**Addendum #1**  
**May 9, 2024**

**11<sup>th</sup> WMD-CST Unheated Storage Building Project, Waterville, Maine - Project No. 23SC20-315-D, Bid Number #24-042**

Directorate of Facilities Engineering

PROJECT: **WATERVILLE ARMORY  
 FIRST FLOOR PLAN**

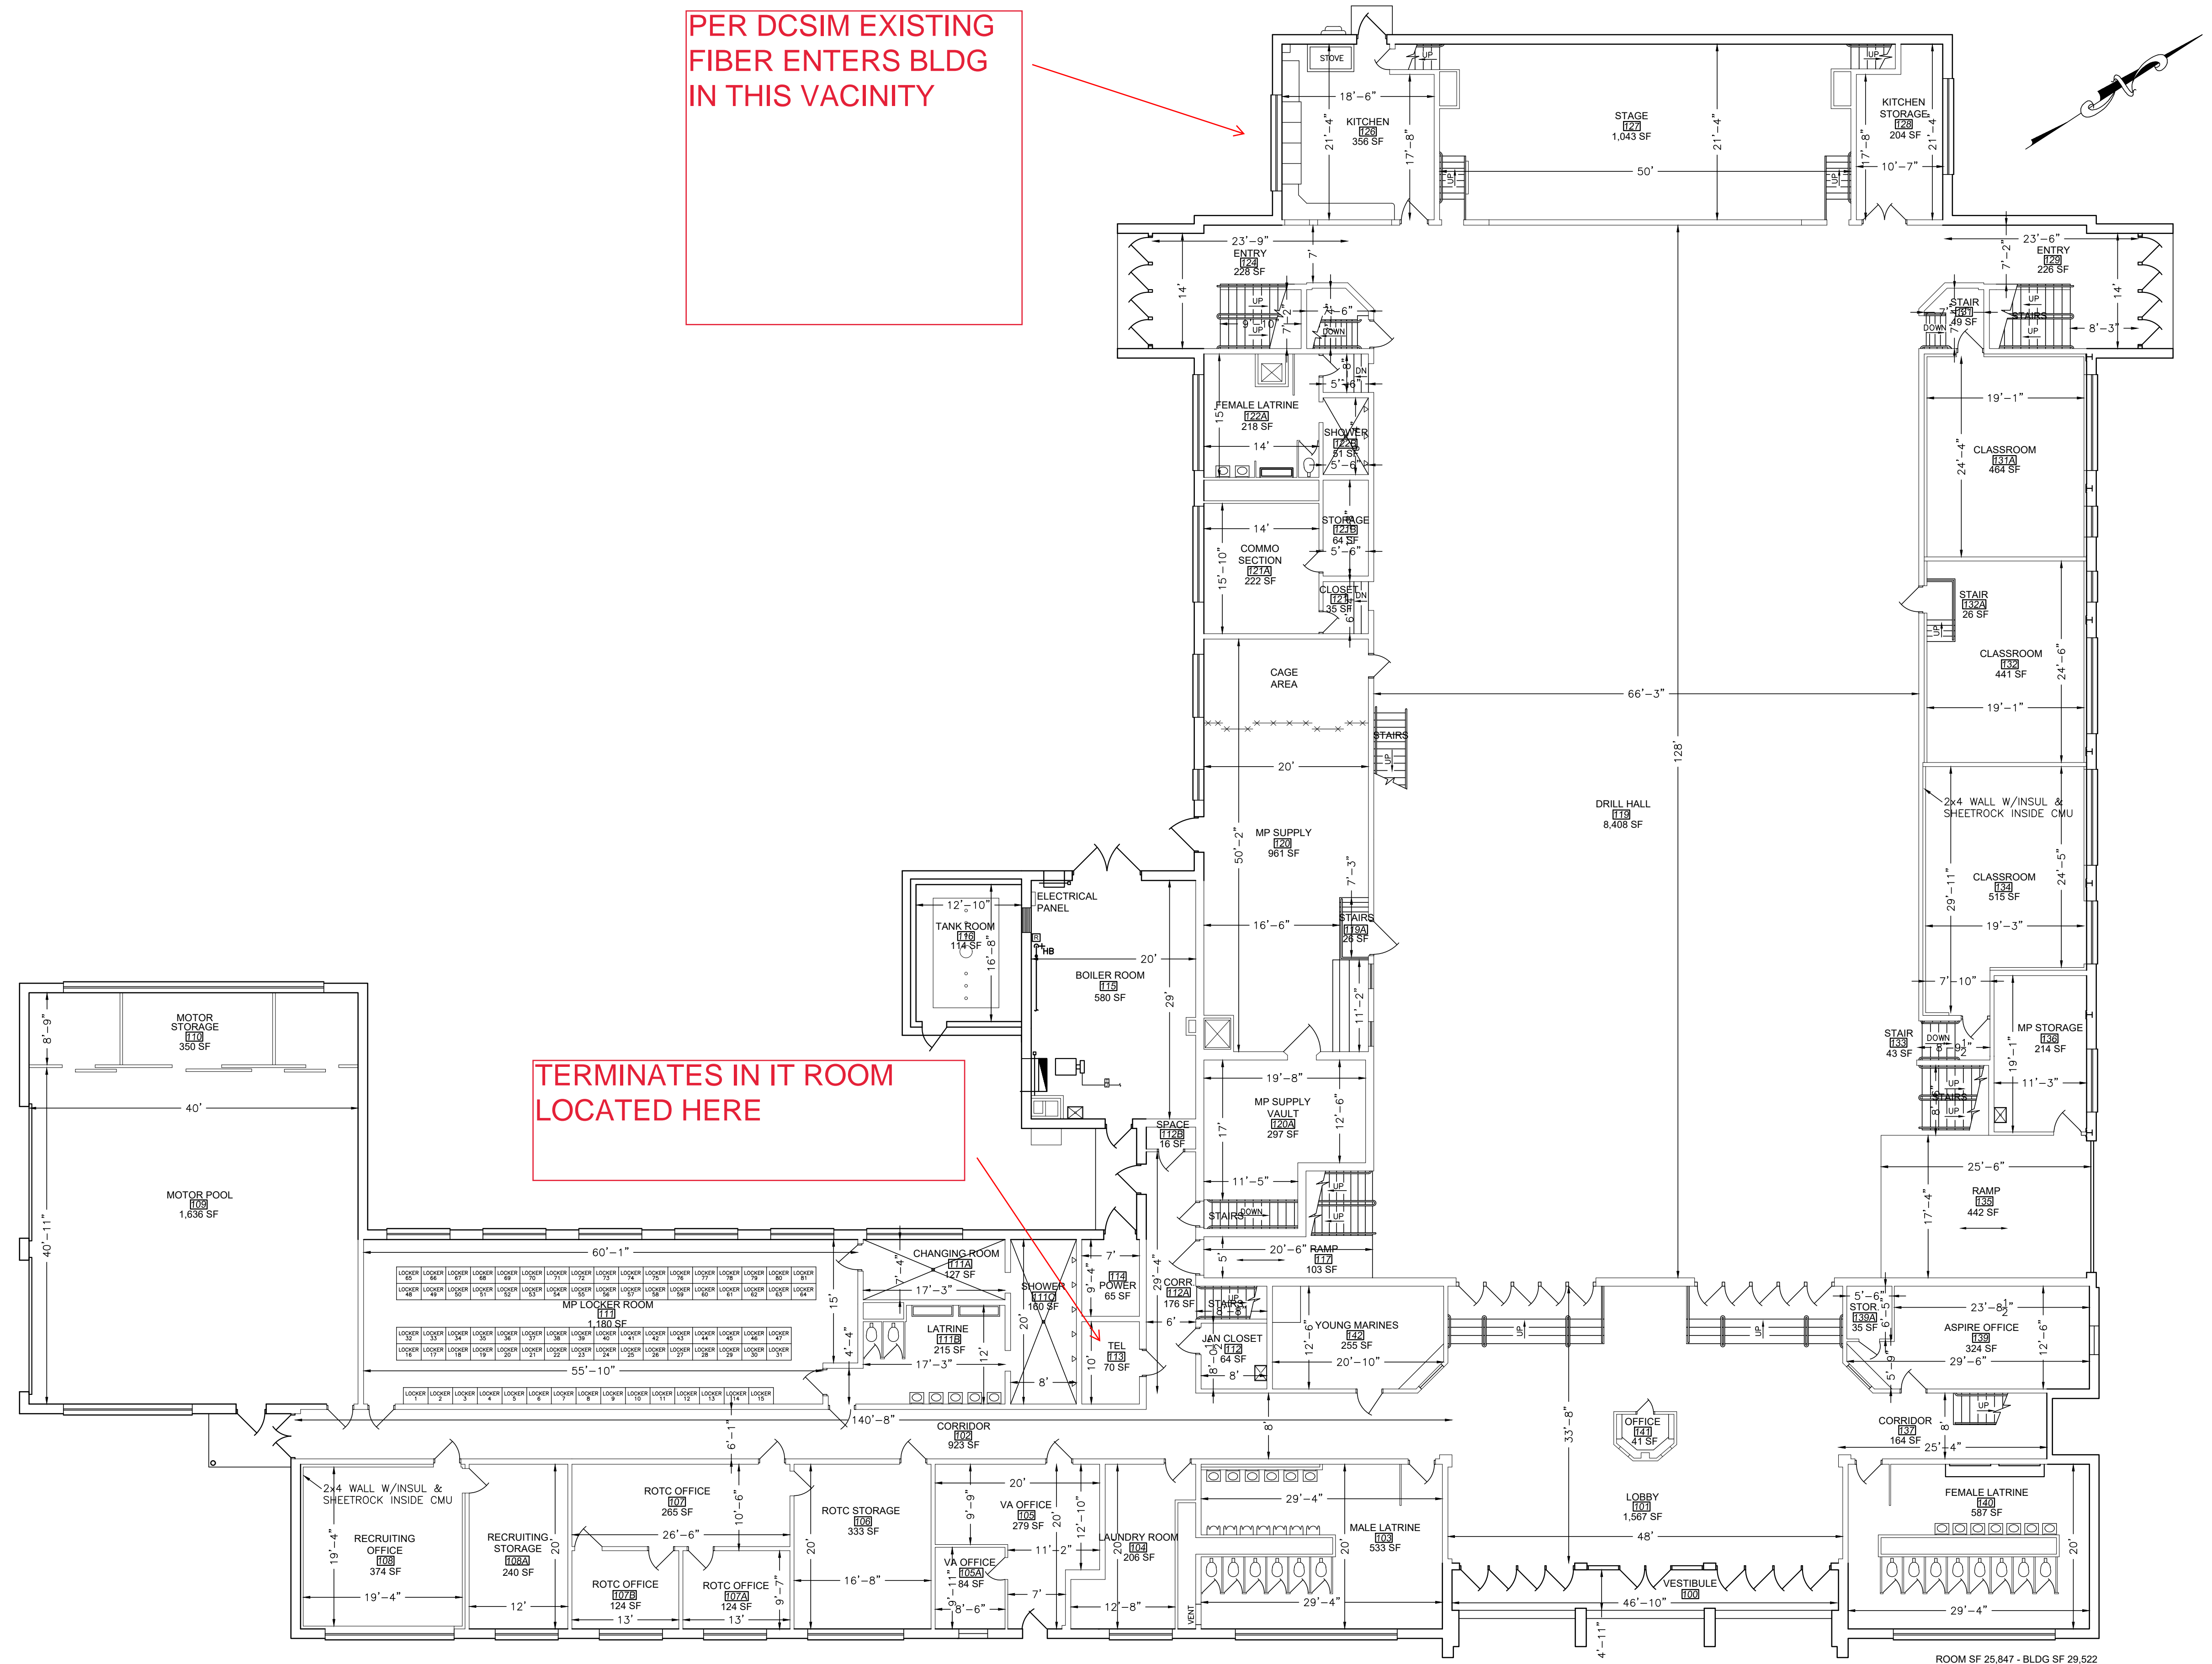
1. There are communication cables that run between the subject WMD/CST facility and the adjacent Waterville Armory that must be replaced prior to construction of the Unheated Storage Building. Include in the Base Bid price the following work and all related ancillary work required to provide a complete and usable communication system between the buildings.
  - a. Approximately 275 linear feet conduit trench with two (2) 4-inch rigid metallic conduits.
  - b. Install new 12-strand fiber and 25-pair copper, single mode, in separate conduits with LC-to-LC connectors, from electrical room in WMD/CST Facility to the IT room in the Waterville Armory so as not to cause a conflict with the new Unheated Storage Building. (See attached plan of Waterville Armory.)
  - c. Provide and submit utility location and topographic survey of proposed

PER DCSIM EXISTING FIBER ENTERS BLDG IN THIS VACINITY

TERMINATES IN IT ROOM LOCATED HERE
